Pentium® Pro Processor Specification Update

Release Date: January 1999

Order Number: 242689-035

The Pentium® Pro processor may contain design defects or errors known as errata which may cause the product to deviate from published specifications. Current characterized errata are documented in this Specification Update.

Figure 4-3. Stack Switch on a Call to a Different Privilege Level

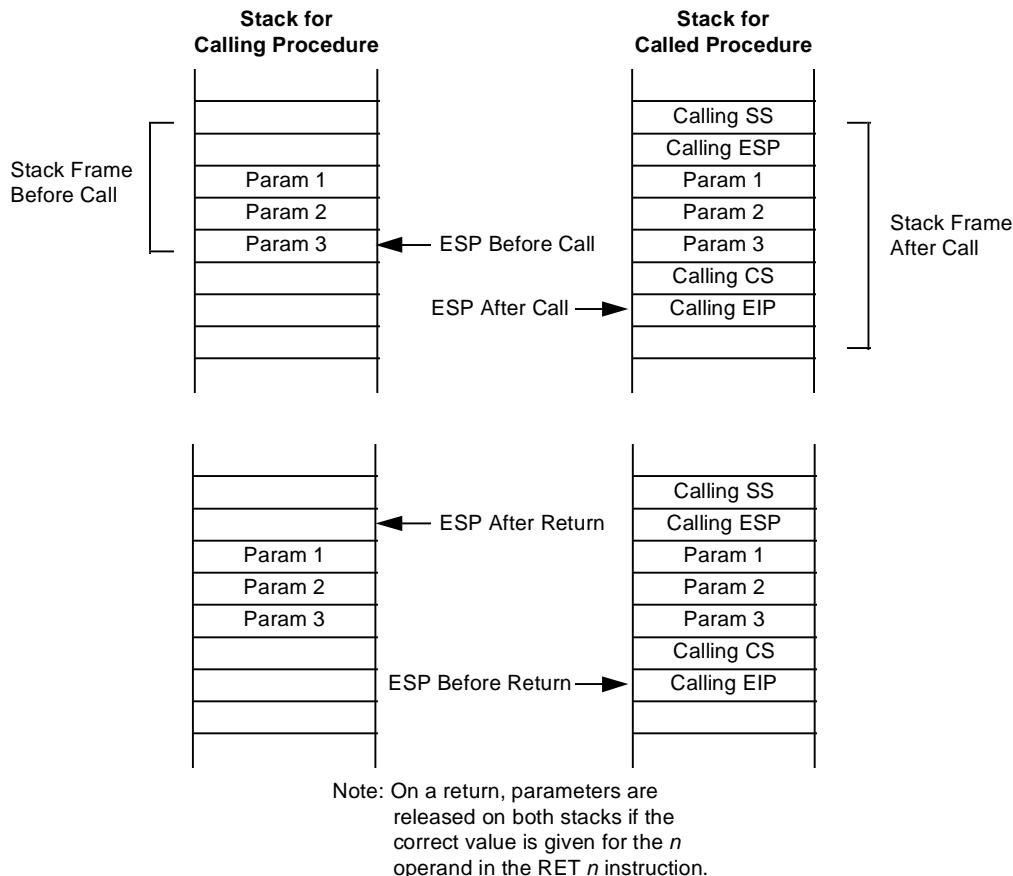
When making a call to a more privileged protection level, the processor does the following (see Figure 4-3):

4. Restores the SS and ESP registers to their values prior to the call, which causes a switch back to the stack of the calling procedure.
5. (If the RET instruction has an optional n argument.) Increments the stack pointer by the number of bytes specified with the n operand to release parameters from the stack (see explanation in step 3).

6. Resumes execution of the calling procedure.

Figure 4-4. Stack Usage on Transfers to Interrupt and Exception Handling Routines

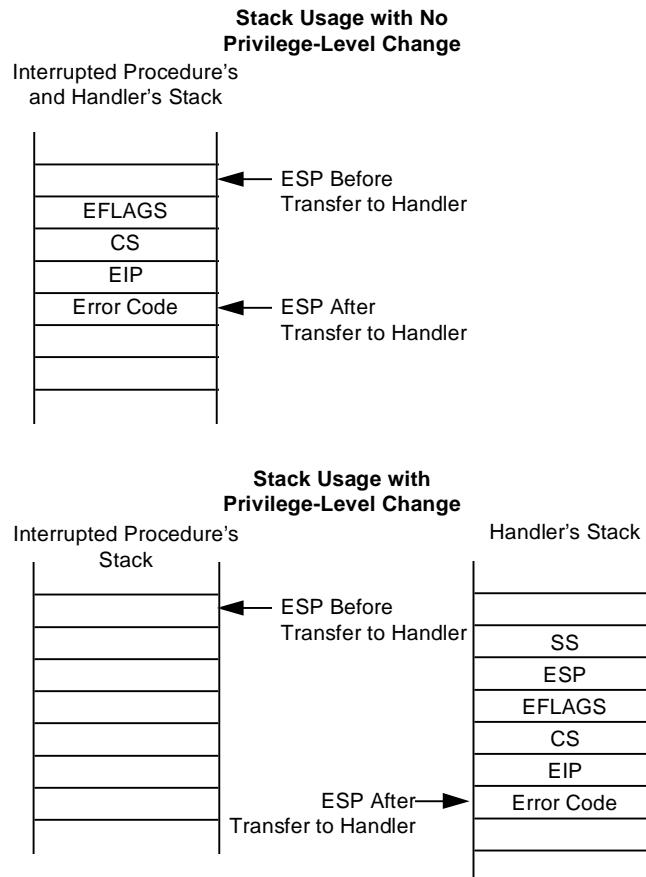
If no stack switch occurs, the processor does the following when calling an interrupt or exception handler (see Figure 44):

1. Performs a privilege check.
2. Restores the CS and EIP registers to their values prior to the interrupt or exception.
3. Restores the EFLAGS register.

4. Restores the SS and ESP registers to their values prior to the interrupt or exception, resulting in a stack switch back to the stack of the interrupted procedure.
5. Resumes execution of the interrupted procedure.
